URGENT Field Safety Notice

Trilogy Evo, Trilogy Evo O2, Trilogy EV300
Flow Sensor Nebulized Aerosol Deposition

19-SEPT-2024

Reference: Flow Sensor Nebulized Aerosol Deposition
Trilogy Evo, Trilogy Evo O2, and Trilogy EV300
2024-CC-SRC-013

Figure 1: Acceptable In-Line Nebulizer Placement.

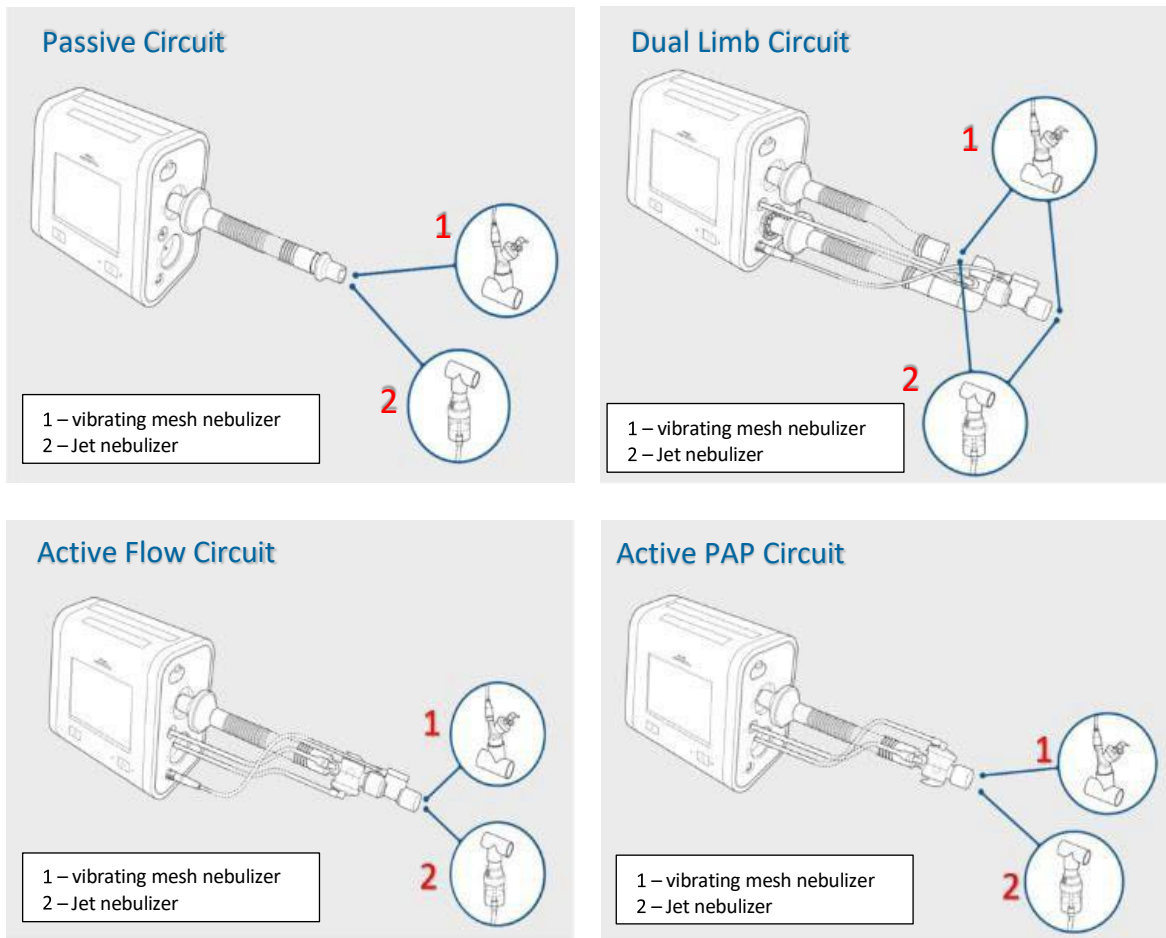
- If using in-line nebulizer treatments:
 - The circuit must be configured as pictured in the images in **Figure 1** below
 - For prescriptions needing tidal volumes greater than 700 mL with a passive circuit, transition patient to alternate circuit (Active PAP, Active Flow, or Dual Limb).
